### **Proposal for Supplement 3 to the 02 series of amendments to Regulation No. 90 (Replacement braking parts)**

#### **Submitted by the Working Party on Brakes and Running Gear\***

## Supplement 3 to the 02 series of amendments to Regulation No. 90 (Replacement braking parts)

- "3. Brake disc design types for L<sub>1</sub>, L<sub>2</sub>, L<sub>3</sub>, L<sub>4</sub> and L<sub>5</sub> categories (examples)  
One-piece type: brake disc with braking surface and bell made in a single piece and, therefore, of the same material

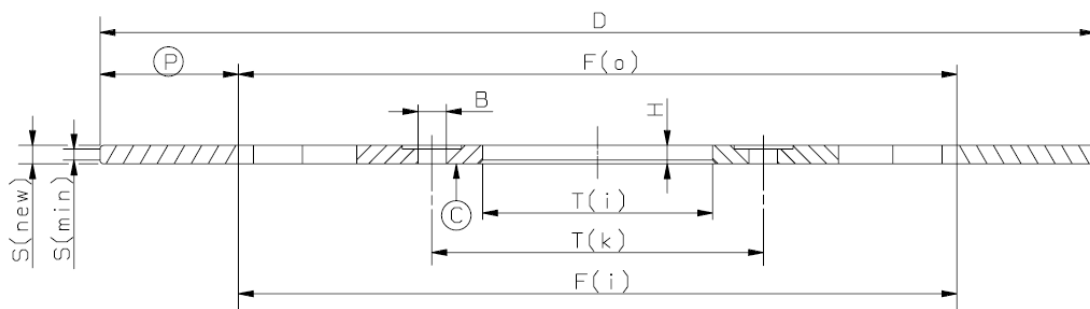
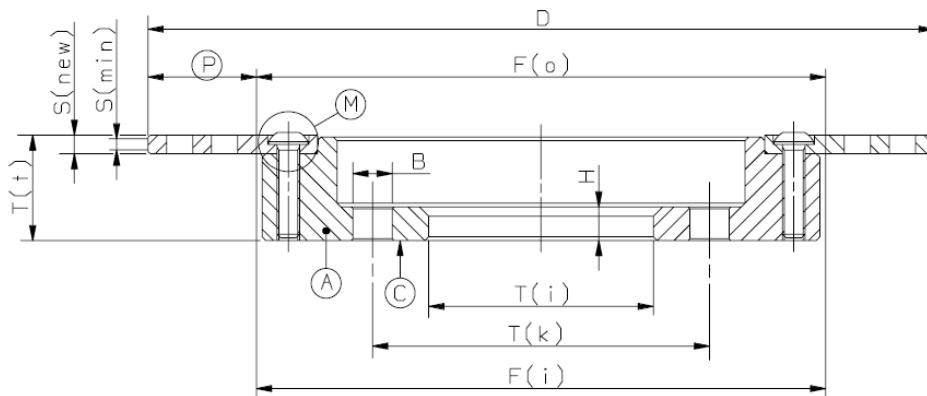
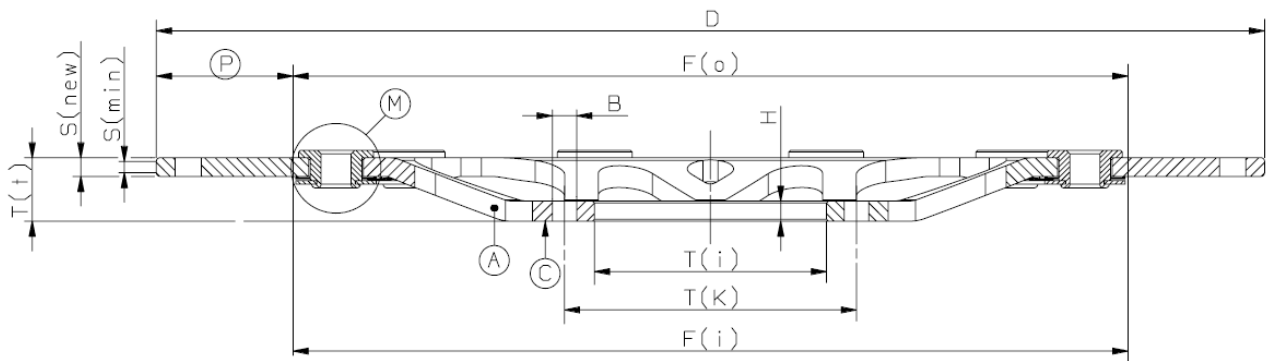
*Add a new paragraph 3., to read:*

Composed fixed type: brake disc having the braking ring made of steel, while the bell is of other material, generally aluminium; the 2 components are rigidly bounded by a screwed or riveted connection.

Floating type: brake disc having the braking ring radially released from the bell, in order to allow its thermal expansion.

- B Diameter of mounting bolt holes (or thread size in case of threaded holes)
- D External diameter of disc
- F<sub>(i)</sub> Inner diameter of friction surface (inboard)
- F<sub>(o)</sub> Inner diameter of friction surface (outboard)
- H Mounting flange thickness
- S<sub>(new)</sub> Disc thickness (nominal)
- S<sub>(min)</sub> Disc thickness (minimal permissible wear thickness)
- T<sub>(i)</sub> Internal diameter (mounting spigot diameter)
- T<sub>(k)</sub> "x" number of mounting bolt holes and pitch circle diameter
- T<sub>(t)</sub> Overall length of disc"

Figure 1

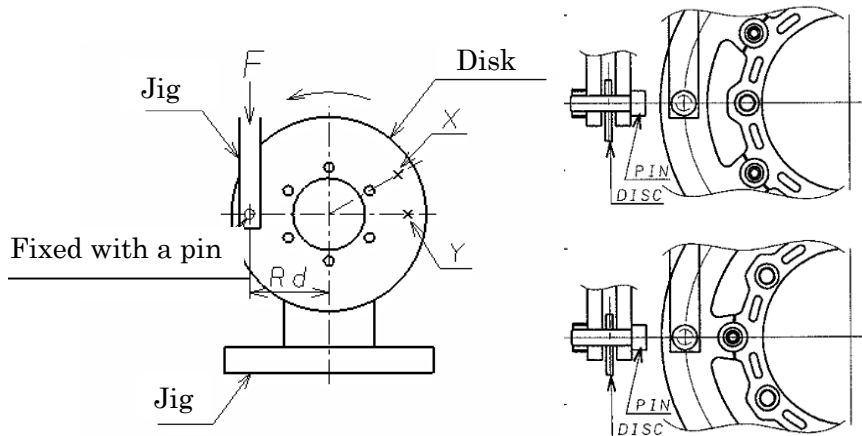
Static test performed on special test bench shown in Figure 1.

- 2.2.1. Drill a hole on the braking surface of the disc at a distance from the centre equal to the effective radius  $R_d$ .
- 2.2.2. Position the disc on the test bench and fasten it using specific fastening screws.
- 2.2.3. Connect the bench arm to the hole drilled on the brake disc.
- 2.2.4. Apply the force  $F$ , specified in Table A14/2.2.5., as shown in Figure 1.
- 2.2.5. Record strokes and forces as shown in Figure 2.

Figure 2  
Movement

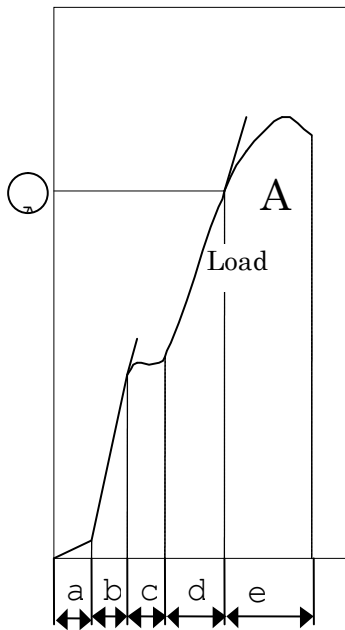
- (a) Adjustment stroke of the equipment (recovery of any clearance between the hole on the braking surface and the connection pin to the bench arm);
- (b) Load developed by the fastening screws to the equipment;
- (c) Movement of the brake disc caused by its rotation with sliding on the plate of the equipment, when the disc's fastening screws bear against the fixing holes of the disc;
- (d) Load supported by the brake disc;
- (e) Permanent deformation of the brake disc (starting from point A).

The disc shall not permanent deformations before reaching the force  $F$  specified in Table A14/2.2.5; the measurement of the deformation force must be performed at point A as in Figure 2.

**Figure 3**

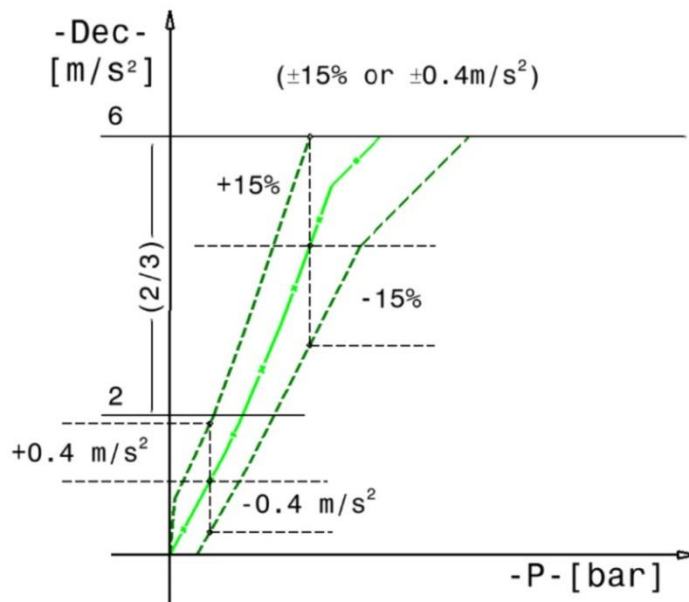
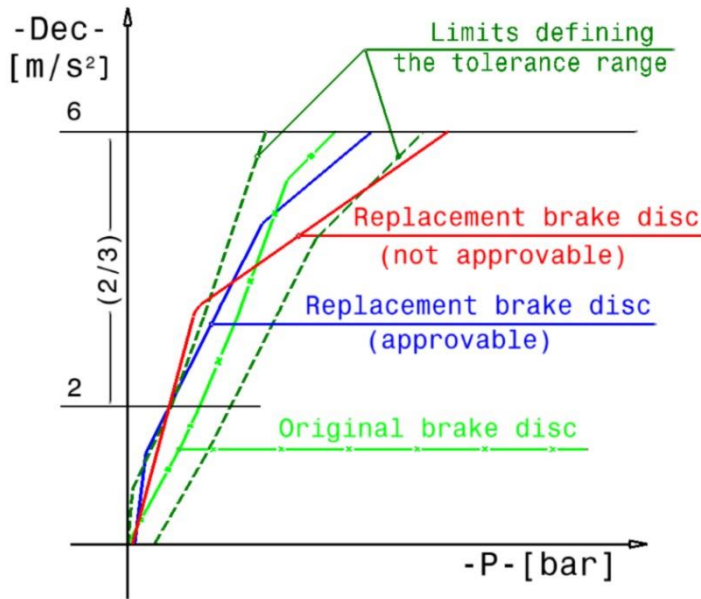
- 3.2.6.3. The brake test described in paragraph 3.2.6.2. also has to be carried out using the original brake disc.
- 3.2.6.4. The dynamic frictional properties of the replacement brake disc can be regarded as similar to those of the original brake disc, provided the values attained in relation to the mean fully developed deceleration at the same operating pressures or control forces in the region of the upper 2/3 of the curve generated do not deviate by either  $\pm 15$  per cent or  $\pm 0.4 \text{ m/s}^2$  from those of the original brake disc (see an example of the curve in Figures 3 and 4).

Figure 1

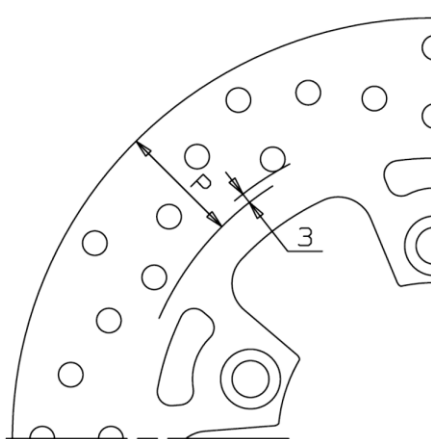
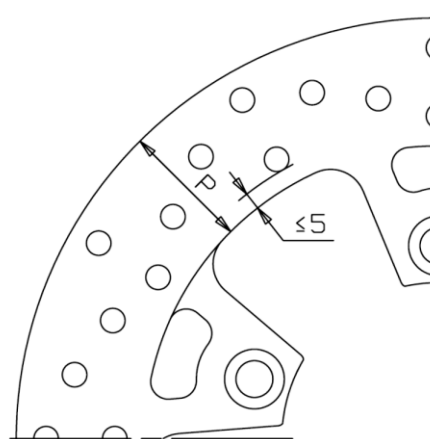
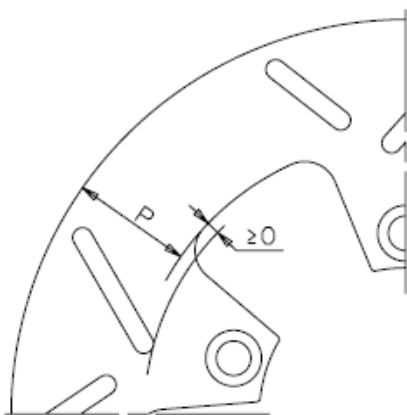
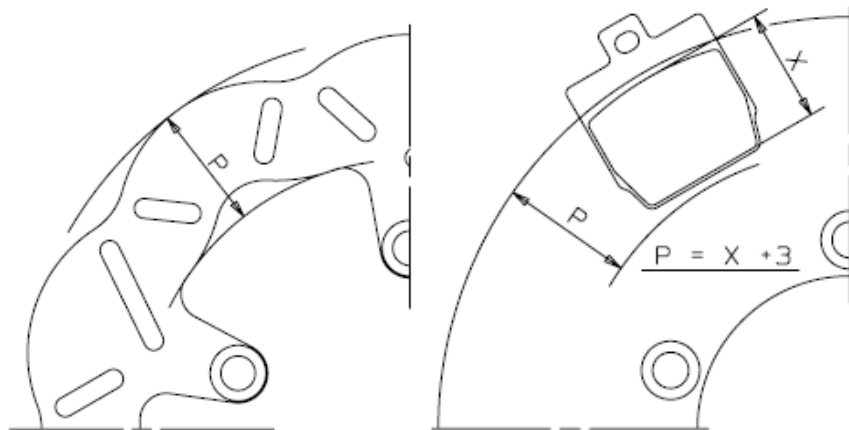
Braking surface means the surface of a brake disc on which the brake pads work. The braking surface width is calculated between the disc outer diameter and an internal diameter defined as follows:

- 1.1. Case of braking surface with lightening (holes, slots, wave, etc.) on the braking surface (Figure 1) only: 3 mm towards the centre of the disc from the end of the lightening.
  - 1.2. Case of braking surface with lightening (holes, slots, wave, etc.) with distance from the disc's internal diameter lower than 5 mm (Figure 2): diameter of the brake disc undercut.
  - 1.3. Case of braking surface with lightening (holes, slots, wave, etc.) which terminate inside, outside the brake disc undercut (Figure 3): diameter of the brake disc internal undercut.
  - 1.4. All other cases: internal diameter defined by the radial width of the largest combinable pad, to which 3 mm need to be added (Figure 4).
